LUCILLE YOUNG SUBDIVISION, RESUBDIVISION OF

LOT 1

APPLICATION NUMBER 24 DATE April 6, 2006
APPLICANT Lucille Young Subdivision, Resubdivision of Lot 1
REQUEST Subdivision

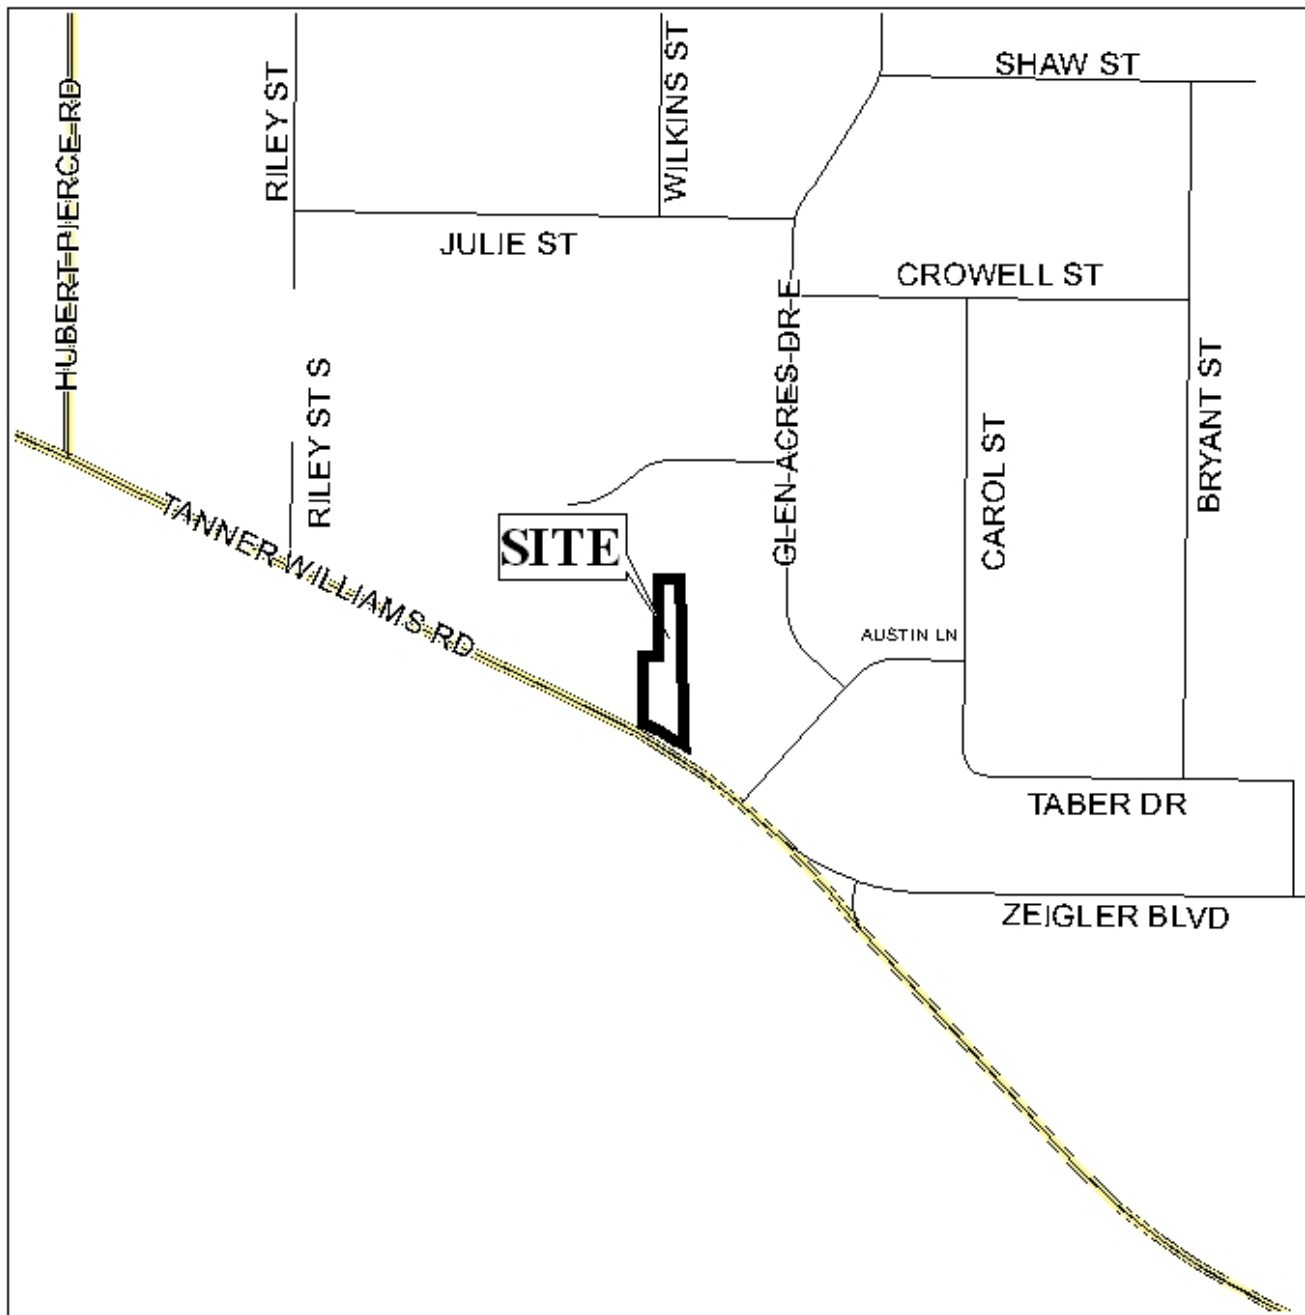
The site fronts onto Tanner Williams Road, a planned major street, and the existing right-of-way is shown as 80 feet on the preliminary plat, however, the plat also shows that 10 feet has been dedicated to Mobile County. The Major Street Plan requires a 100 foot right-of-way; therefore, dedication of sufficient right-of-way to provide 50 feet from the centerline of Tanner Williams Road should be required unless the 10 feet indicated on the preliminary plat reflects the dedication required as part of the June 2002 subdivision approval. If required by additional dedication, the 25-foot minimum building setback line depicted on the preliminary plat should be revised to reflect the new right-of-way edge along Tanner Williams Road; otherwise the 25-foot minimum building setback line depicted on the preliminary plat complies with the Subdivision Regulations.

Since Tanner Williams Road is a proposed major street, access management is a concern. The original approval stipulated that lots share curb-cuts onto Tanner Williams, however, year 2002 aerial photos indicate that the existing Lot 1 has multiple curb-cuts onto Tanner Williams. It is recommended, therefore, that no new curb-cuts be permitted; the redesign or relocation of curb-cuts must be approved by Mobile County Engineering.

The subdivision will create two lots, one of which is a flag lot. Four flag lots exist within ¼ mile of the site, and many other lots in the vicinity exceed the depth to width ratio recommended in Section V.D.3. of the Subdivision Regulations. The minimum buildable width for Lot 1-B, required by Section V.D.2., is provided at a distance of approximately 385 feet from Tanner Williams Road. Lot 1-B will have approximately 30 feet of frontage on Tanner Williams, but only a 25-foot wide “flagpole,” while Lot 1-A will have approximately 155 feet of frontage.

The 85,576 square feet ± site appears to contain four dwelling units (a single-family residence and three mobile homes). The minimum lot size required for a site with public water and individual septic systems, such as this site, is 15,000 square feet. Lot 1-A will be approximately 45,314 square feet, while Lot 1-B will be approximately 40,261 square feet, with approximately 9,847 square feet of the lot comprising the “flag pole” portion of the lot. While the proposed lots will meet the minimum size requirements of Section V.D.2., the applicant should consult the Mobile County Health Department to ensure that the site has adequate room for on-site septic systems.

With a waiver of in Section V.D.3. of the Subdivision Regulations, the plat is recommended for Tentative Approval, subject to the following conditions: 1) dedication of sufficient right-of-way to provide 50 feet from the centerline of Tanner Williams Road, if necessary, to comply with the requirements of Section V.B.14. of the Subdivision Regulations; 2) adjustment of the 25-foot setback line, if necessary, to reflect the right-of-way dedication; 3) the placement of a note on the Final Plat stating that any lots which are developed commercially and adjoin residentially developed property must provide a buffer, in compliance with Section V.A.7. of the Subdivision Regulations; 4) placement of a note on the Final Plat stating that no additional curb-cuts are permitted, and that the redesign or relocation of curb-cuts must be reviewed and approved by the Mobile County Engineering Department; and 5) placement of a note on the Final Plat stating that no additional subdivision of Lot 1-B is allowed until additional roadway frontage is provided by either a public or private road onto the property that is constructed to the standards contained within Section VIII.E.2. of the Subdivision Regulations.
